PROPOSED POULTRY UNITS AT
YELD FARM
Drainage Gate Layout and Spec

- 1.1.1. This Addendum to the Environmental Statement has been produced by ADAS UK Ltd. on behalf of the applicant Mr. S. Eckley to accompany the planning application for four proposed new poultry units at Yeld Farm in Lyonshall, Hereford.

Environmental Addendum for the Proposed Poultry Units at Yeld Farm, Lyonshall

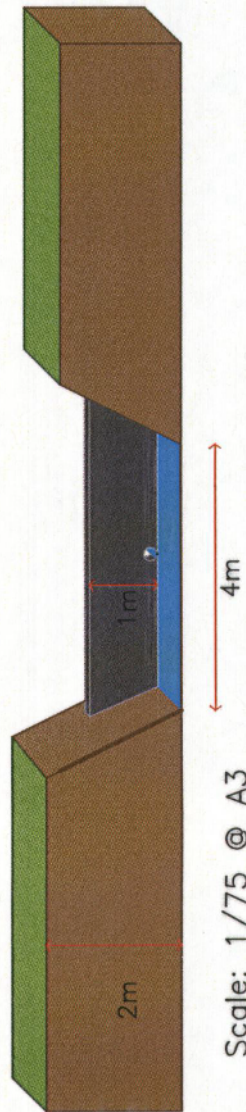
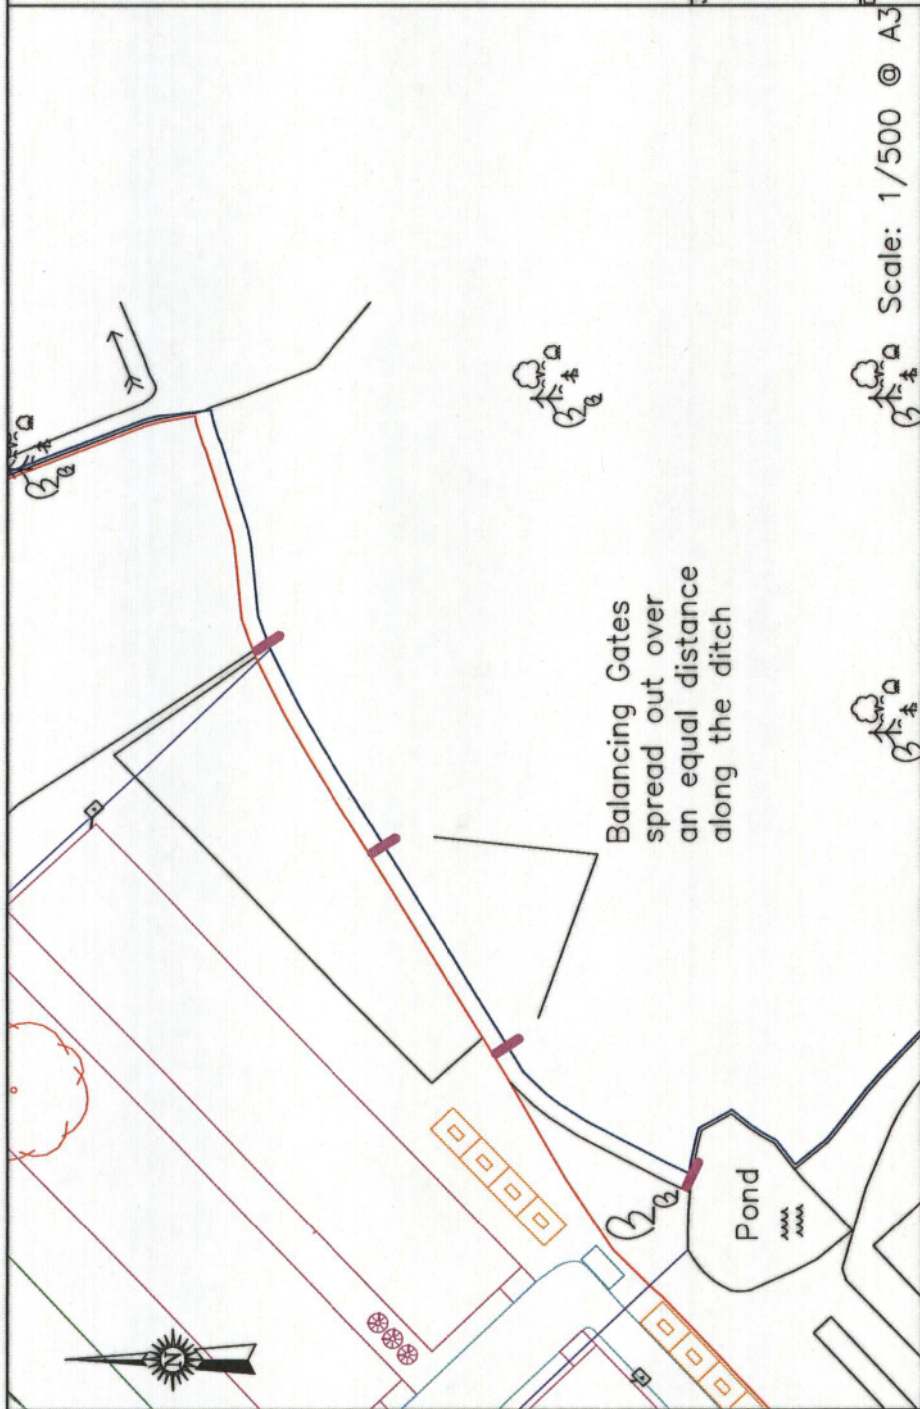
- 5.3.4. The Environmental Statement calculated the amount of the storm water requiring attenuation based on the 1 in 100 year storm. In order to accommodate the additional requirement, it is proposed to modify the existing ditch into a balancing/attenuation ditch. The ditch will be widened to 4m and four barriers installed. The barriers will include a pipe passing through it which will allow a limited flow through the barrier and limit the discharge into the brook to that of the existing green field rate. The compartments that the barriers create provide for temporary storage of water during heavy rain as the flow is restricted through the barrier. As the barrier will not be as high as the ditch it will allow for some overflow into the next compartment during heavy rain.

- 5.1.1. Natural England requested that detailed designs of the Sustainable Drainage System are agreed. The Environment Agency had no objection to the proposed development but did recommend that prior to the site becoming operational further details needed to be provided as to the proposed disposal methods to ensure that they pose no pollution risk to the pond and associated watercourses.

- 5.3.5. The ditch will be designed based on the calculations in the Environmental Statement and the soil permeability figures which will be assessed during the ditch widening. Figure 5.1 provides drawings of the preliminary attenuation ditch design.
- 5.3.6. The ditch will be maintained and regular inspection and periodic cleaning will be undertaken.
